**ILLUSTRATIVE MASTERPLAN FOR THE PROPOSED DEVELOPMENTS IN THE
NUTFIELD GREEN PARK AREA.**

**COMMENTS FROM EPG LIMITED ON BEHALF OF TANDRIDGE DISTRICT COUNCIL
ON THE SCOPE OF THE 2023 SITE INVESTIGATIONS AND ON THE PRELIMINARY
DRAFT 2023 SITE INVESTIGATION REPORT**

Nutfield - EPG review of geoenvironmental work

RE: Third party review of geoenvironmental assessments at Nutfield Park

Figure 5 - Extent of the gas extraction system within North Cockley Quarry Landfill

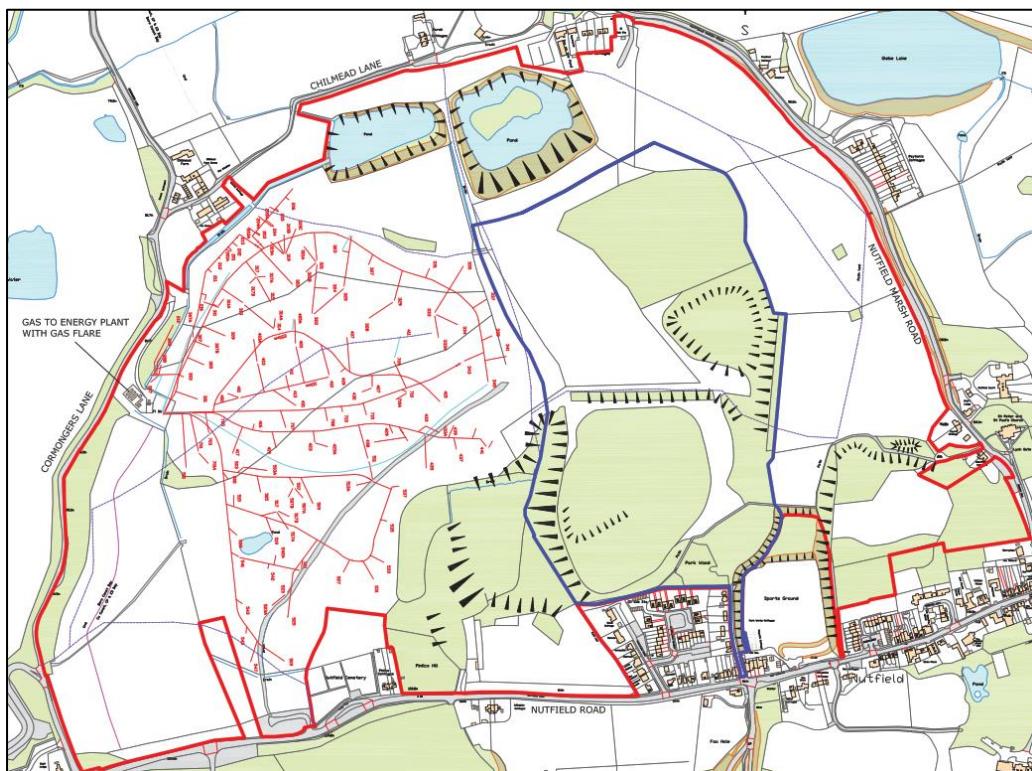
A series of gas extraction boreholes are understood to be present within the North Cockley Landfill site. These boreholes are connected by below ground gas collection pipelines which are designed to extract landfill gas from the waste mass for electricity generation. The gas extraction / energy plant shown in Figure 5 below is operated under license by Arevon Energy Limited. The extraction system will limit the potential for offsite migration of ground

gas while it is in operation, however it is not designed directly for this purpose and the current operating details of the system are unknown.

Assessment of the landfill gas regime in and around North Cockley Landfill by EPG in 2014 concluded that whilst gas concentrations were high within the landfill (up to circa 70% methane and 40% carbon dioxide), associated volumes were low. These observations indicate that diffusive flow is likely to be the main mechanism for migration of methane and carbon dioxide from the landfill toward off-site receptors, although this may be in combination with advective and dissolved phase migration.
